JRPP No:	2010STH010
DA No:	DA-2010/574
PROPOSED DEVELOPMENT:	Replacement of western grandstand at WIN Stadium
APPLICANT:	NSW Communities
REPORT BY:	Theresa Whittaker, Senior Development Project Officer, Wollongong City Council (02) 4227 7481

Assessment Report and Recommendation

01 LEVEL 01 PLAN
1:250

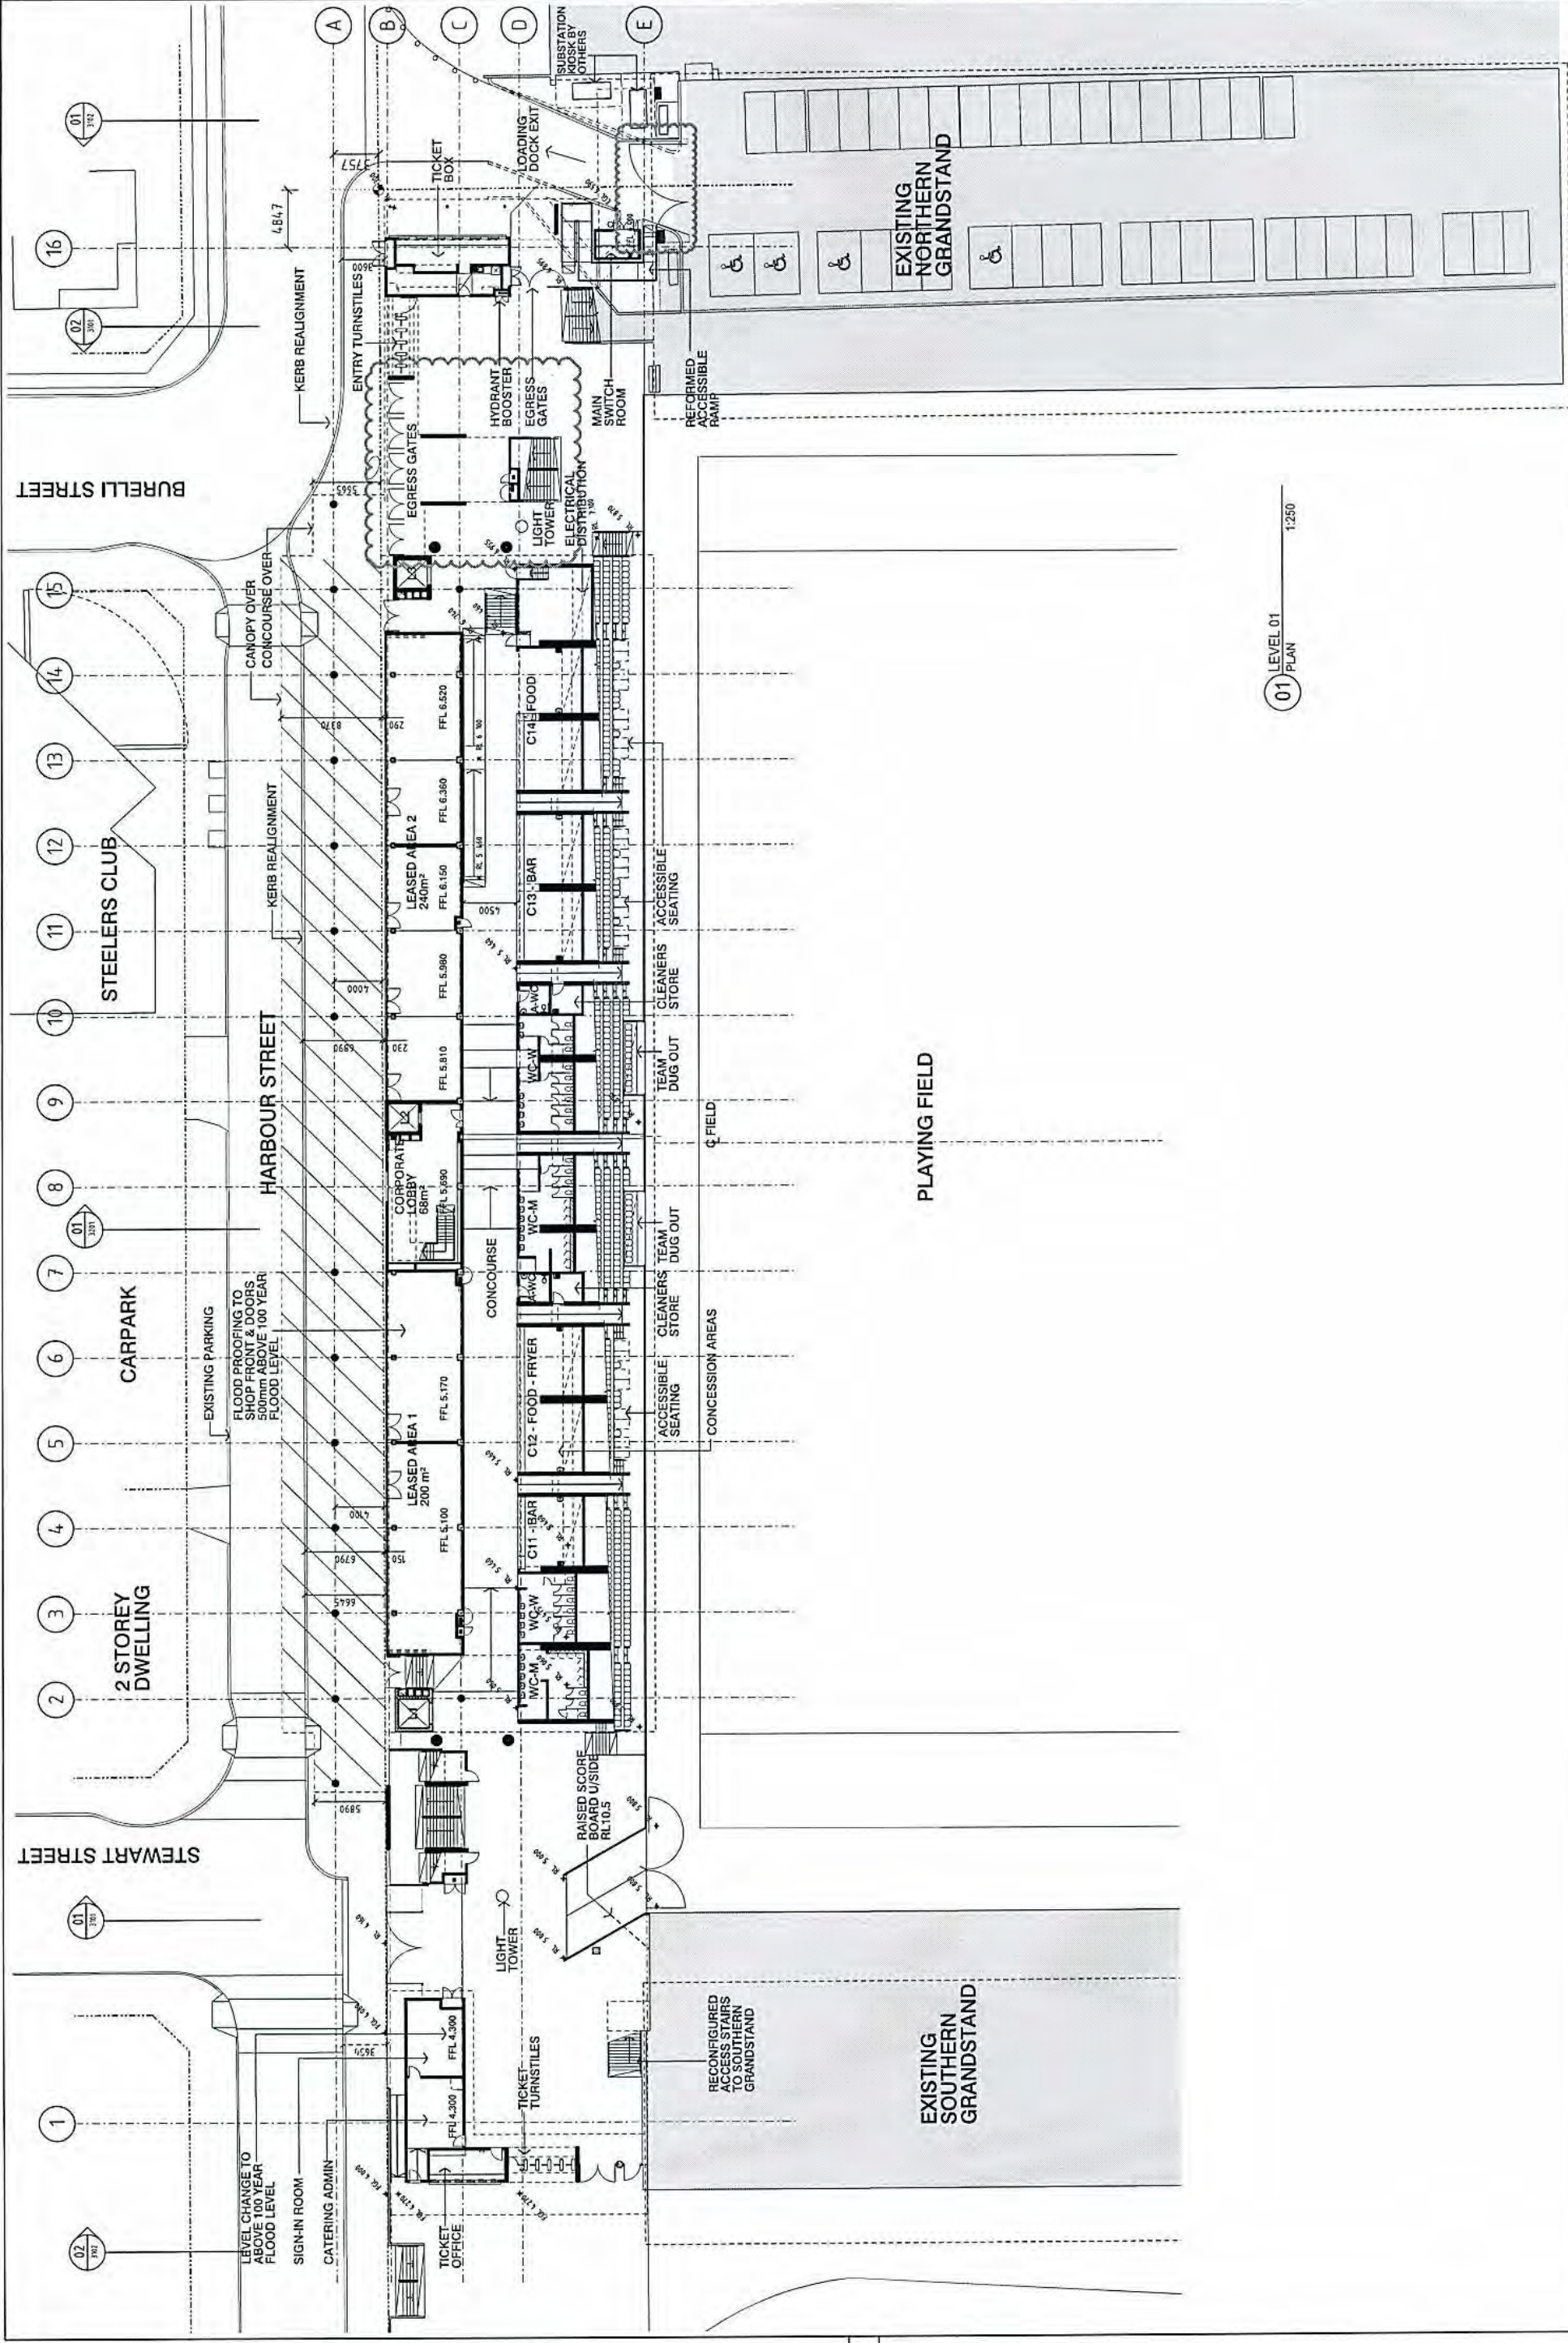
Applicant's response:

“The northern entry stairs and egress have been amended as shown on plan DA 2100_D to provide patrons with a greater area of circulation space to access the stairwells and exit the stadium. In regard to the latest UDRP comments of 21 July 2010, the northern stairs are not intended to be amended further as it is considered the proposed design provides significant improvement to the egress from the ground level to Harbour Street and ingress/ egress from the upper floors of the grandstand.”
